**Messing and Inworth Action Group Limited (MIAG)**

**Messing-cum-Inworth Parish Council (Mcl PC)**

**Position paper and response to documents received from**

**National Highways Limited (NH)**

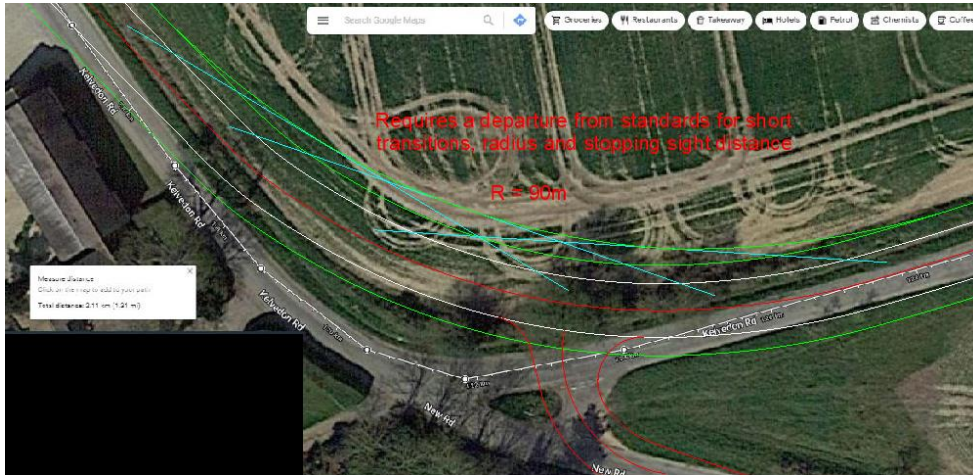
This section of the alignment presents a problem in that the existing radius here is only about 40m. The lowest value for a CD 109 compliant horizontal radius is 90m but as stated previously this radius would require very long transition lengths for a 70kph design speed. The design speed calculated for this road improvement (see Appendix 1) was 70kph, category A. For a category A design, a relaxation in horizontal radius of up to 3 steps is permitted. A 90m radius is a 4-step relaxation and is therefore a departure from standards. It would also require a considerable amount of verge widening to accommodate a stopping sight distance of 120m appropriate for a 70kph design speed. This would push the back of verge on the inside of the curve approximately 25m into the property on the south side, measured from the existing road edge. A reduction in stopping sight distance would also be a departure since there are accesses in this area.

A compromise in the design standards would therefore be necessary to provide a solution that would reduce the impact on properties but still provide a reasonable standard of design. Departures from standards would need to be applied for and could be mitigated by applying a lower speed limit over the length of alignment where the departures occur.

One possible solution would be to provide a 90m horizontal radius curve with transition curves of 49.6m length (ie. half-length) and a stopping sight distance of 70m. This would comply with a design speed of 50kph and with an advisory speed limit of 20mph applied would be a reasonable compromise. However, it would still encroach into the property on the south side by up to 14.5m from the existing road edge. There would still be a considerable impact on mature trees and hedgerows. Overhead cables and poles would also need to be moved.

#### 1.0 From Kelvedon Road into Harborough Hall Road assuming no vehicles parked.

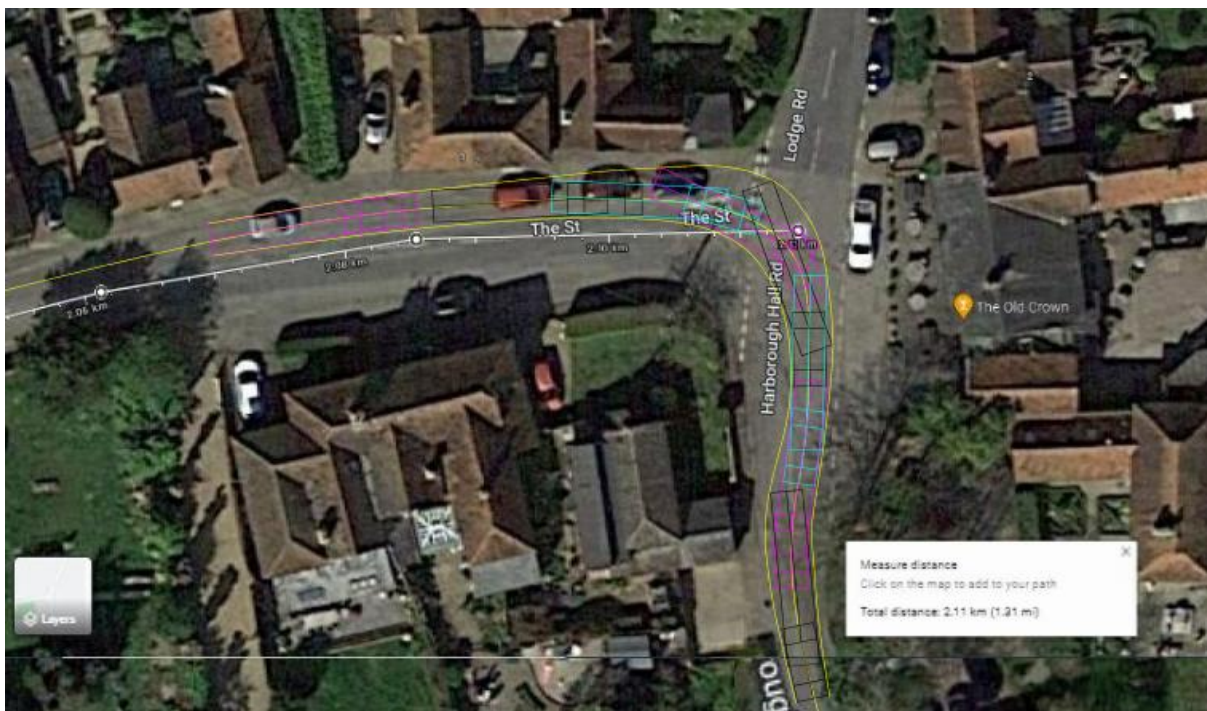
The design vehicle would be able to approach the T junction without impeding vehicles travelling in the opposite direction, on Kelvedon Road. After turning right into Harborough Hall Road, the design vehicle would occupy nearly the full width of the road and therefore require vehicles travelling in the opposite direction to give way. Harborough Hall Road is quite narrow making it difficult for vehicles travelling in the opposite direction to find somewhere to give way.

## 3.0 Harborough Hall Road to Kelvedon Road assuming no vehicles parked.

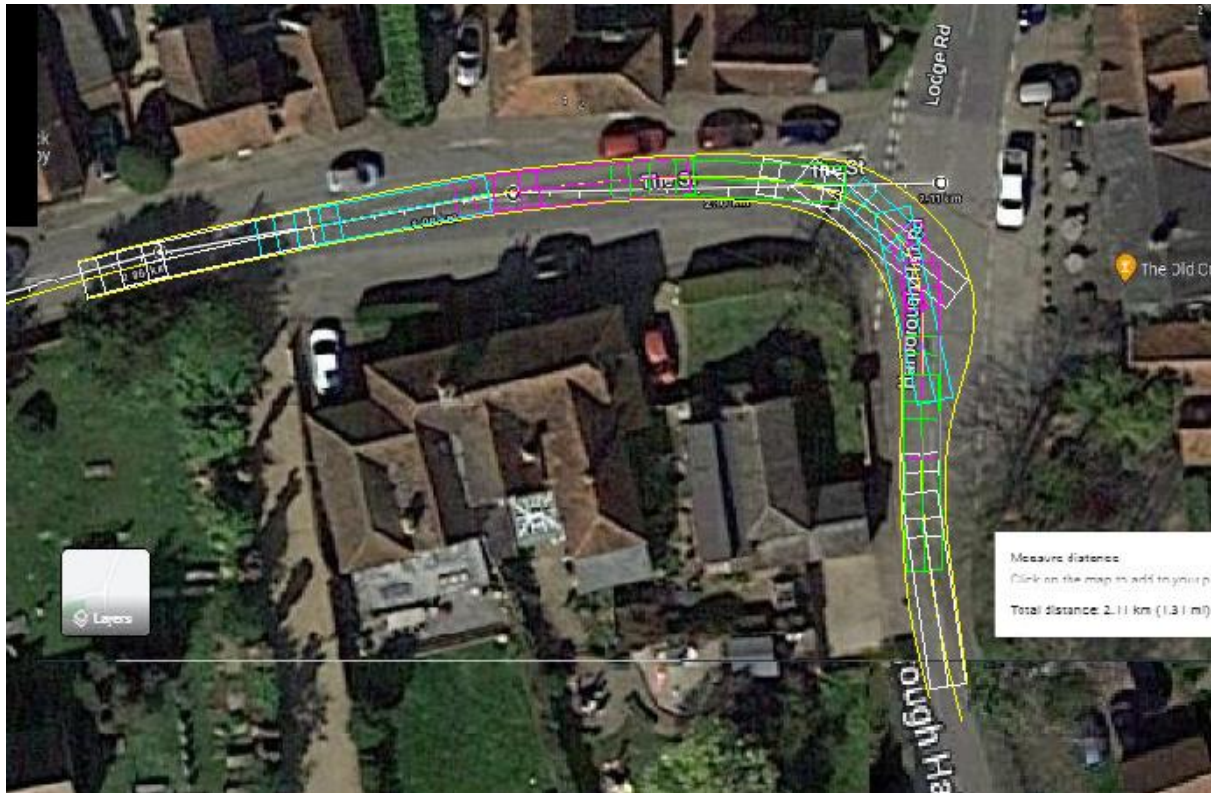
On approach to the T junction along Harborough Hall Road the design vehicle would occupy nearly the full width of that road. Where the road widens at the junction the design vehicle would need to occupy most of the opposing carriageway before turning left into Kelvedon Road, to allow for the swept path of the trailer. Vehicles travelling in the opposite direction would need to give way but with no parked vehicles there would be space to do this. On entering Kelvedon Road the design vehicle might need to cross into the opposite carriageway slightly. This would not leave much width for vehicles travelling in the opposite direction and most likely they would need to give way to the design vehicle.

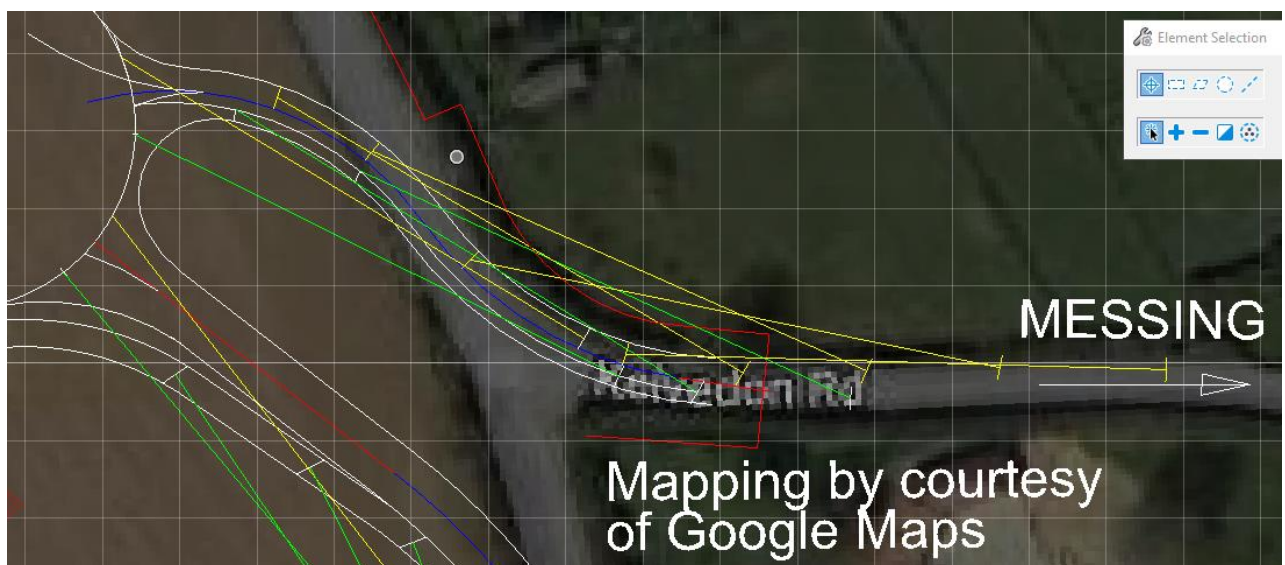
- Forward visibility on approach to the roundabout will not comply with CD 109 unless the sight line passes outside the Red Line boundary into the property “Park Farm” (or “Stonefield Farm”?). Visibility would be further impeded by proposed tree planting.

The alignment is not long enough to make a judgement about visibility in the vertical plane. It would need to be extended further along the B1023 in order to see what the existing carriageway geometry is. The use of a vertical crest curve with  $K = 30$  would indicate a 70 kph design speed since no relaxations are permitted on the immediate approach to a junction (CD 109 table 2.10, CD 109, para. 2.11). The sight line would most likely be impeded by property boundaries where it passes outside the Red Line boundary.

## 2. Inworth Road Roundabout arm to Kelvedon Rd. in the direction of Messing

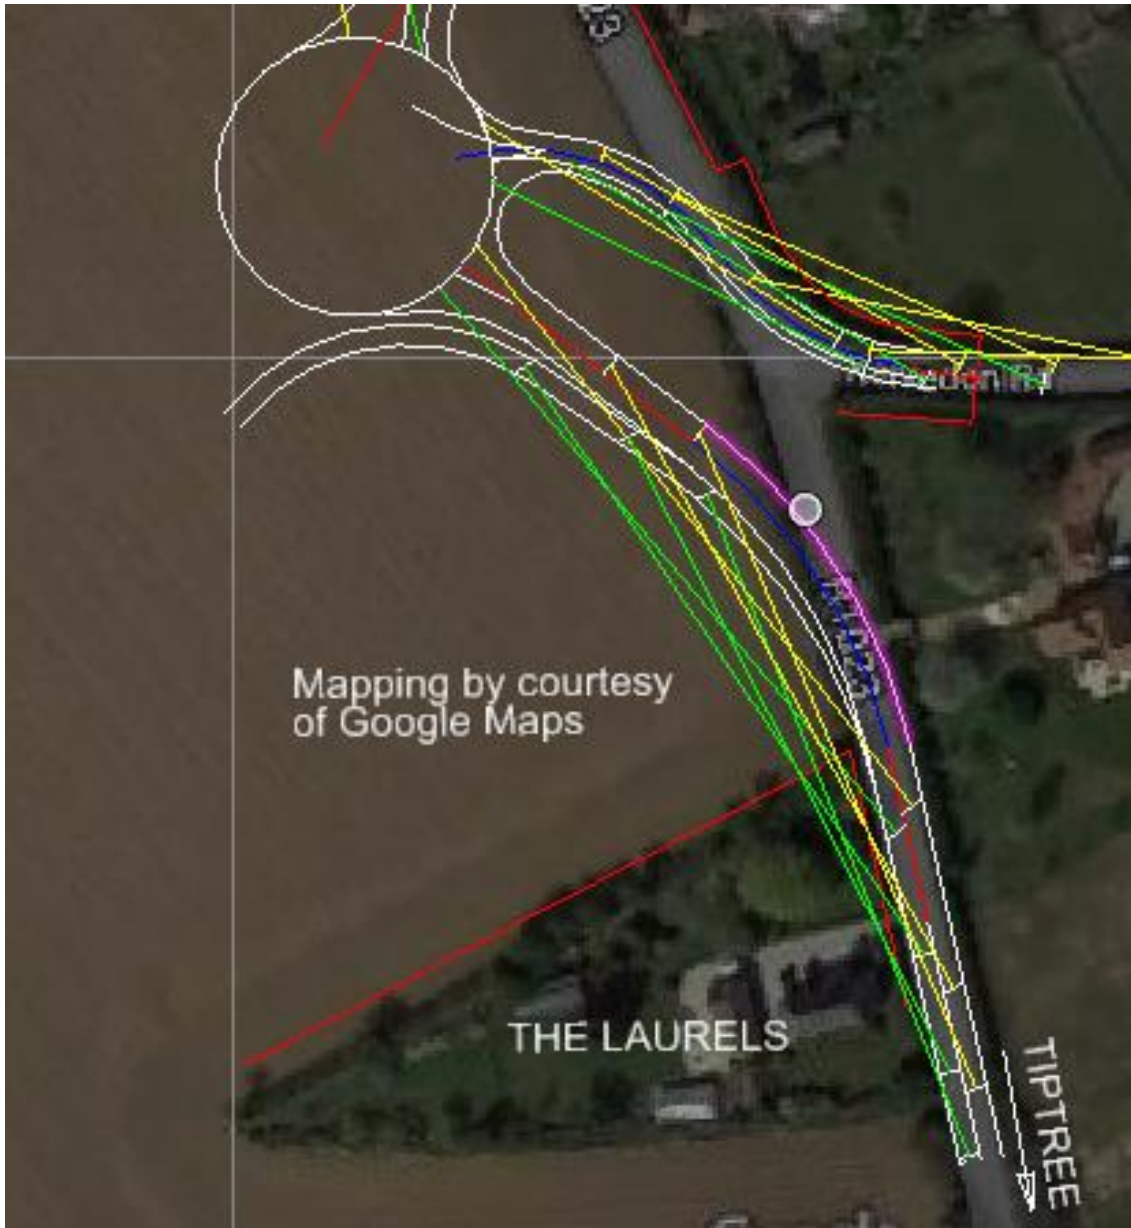
- Forward visibility on approach to the roundabout will not comply with CD 109 unless the sight line passes outside the Red Line boundary on the north side of Kelvedon Road. Visibility may be further impeded by proposed tree planting.

The alignment is not long enough to make a judgement about visibility in the vertical plane. It would need to be extended further along Kelvedon Road in order to see what the existing carriageway geometry is. The use of a vertical crest curve with  $K = 10$  would indicate a 50 kph design speed. Since no relaxations in vertical curvature are permitted on the immediate approach to a junction 50kph would be the highest value of design speed for a crest  $K$  value of 10 (CD 109 table 2.10, CD 109, para. 2.11). The sight line would most likely be impeded by property boundaries where it passes outside the Red Line boundary.
